**Report to
Development Permit Panel**

To: Development Permit Panel
From: Brian J. Jackson, MCIP
Director of Development
Date: April 3, 2008
File: DV 07-374149
Re: **Application by Sanford Design Group for a Development Variance Permit at
12020 No. 5 Road and 12040 Rice Mill Road**

PLAN # 1

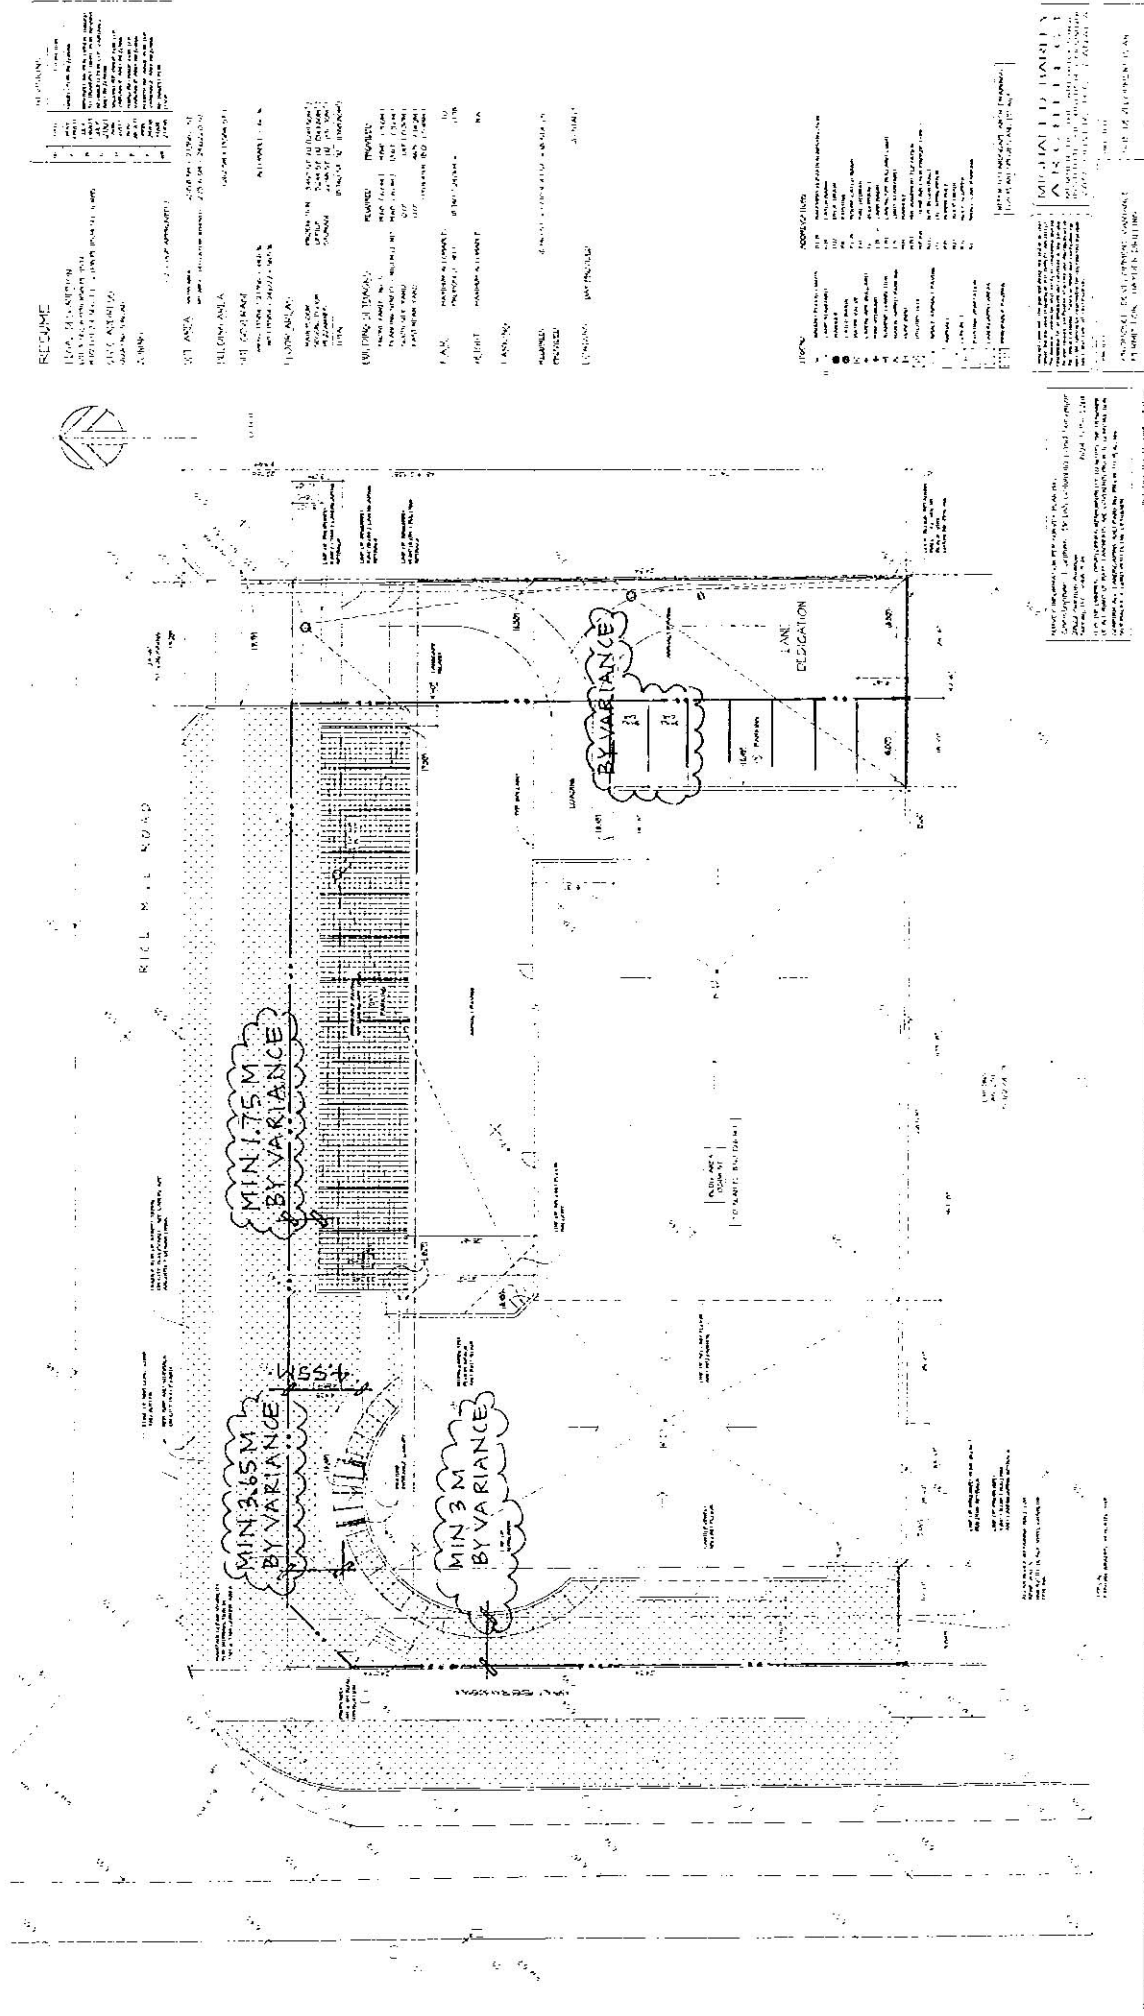
- 1) Reduce the minimum road setback from 6 m to 3 m along No. 5 Road and 3.65 m along Rice Mill Road.

(Staff supports the proposed variance as siting the building close to the intersection helps define the corner and allows the surface parking to be located behind the building. Due to the stepped articulation of the building, the variance is limited to portions of the building, and the larger warehouse portion of the building exceeds the setback requirement. The building’s architectural features and activity inside animate the No.5 Road and Rice Mill Road streetscapes at the corner. If the building was located at the back of the site with parking in front, a variance would not be required, but the urban design would be significantly less appealing).

- 2) Reduce the minimum parking setback from 3 m to 1.75 m along Rice Mill Road.

(Staff supports the proposed variance as it is limited to the northeast portion of the site and is mitigated with an intensive planting strip including tree and planting as well as permeable paving).

- 3) Permit 10% small car parking spaces (2 of 20 parking spaces).

(Staff supports the proposed variance as it is limited to staff parking in the southeast portion of the site and is the direct result of raising the grade and lane up to the required 2.6 m flood construction level. A wider parking space is provided in the southeast corner of the site to allow for opening and closing of doors next to a temporary guard railing which has been provided until the lane continues southward with future development.

PLAN #2
DV07374149
APR 27 2008

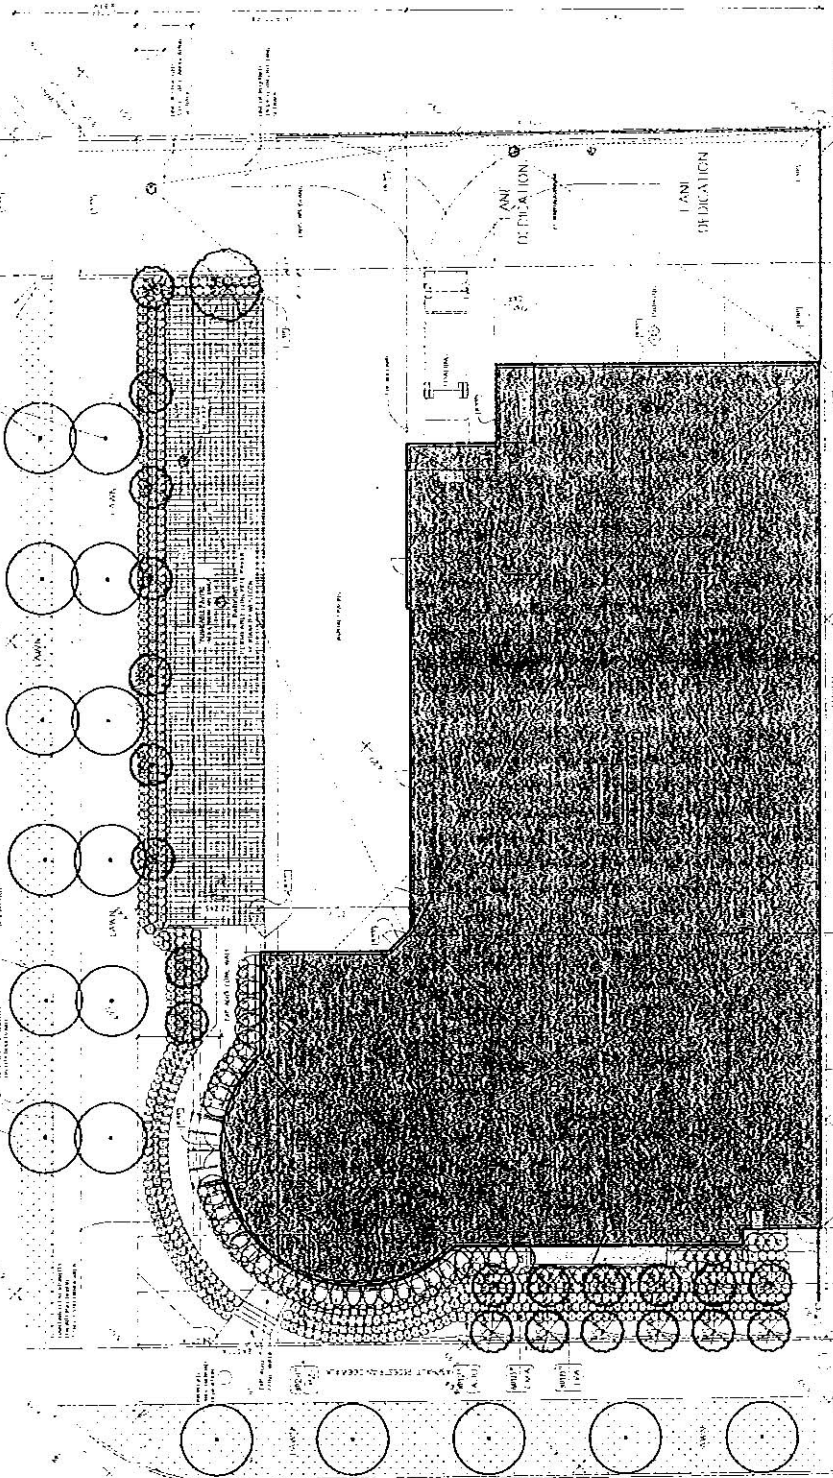
ALL WORKS IN CITY LANDS BY SEPARATE SERVICING AGREEMENT INCLUDING ADDITIONAL ROW OF STREET TREES ALONG RICE MILL ROAD
